METER

■COMBINATION METER

On the ’07 Sienna, the combination meter has been changed as follows.

▶ Optitron Display Type Combination Meter ◀

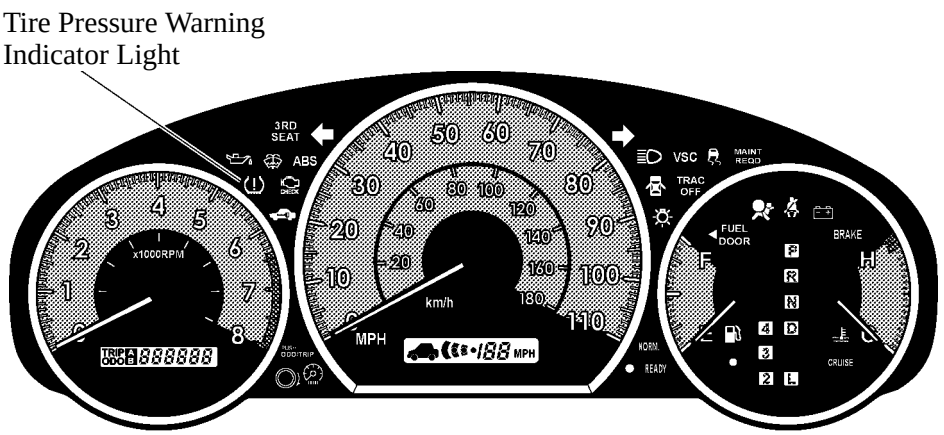
- Along with the use of the 2GR-FE engine, the red zone indication on the tachometer has been changed to 6400 - 8000 rpm.
- The indication design of the tire pressure warning indicator light has been changed.
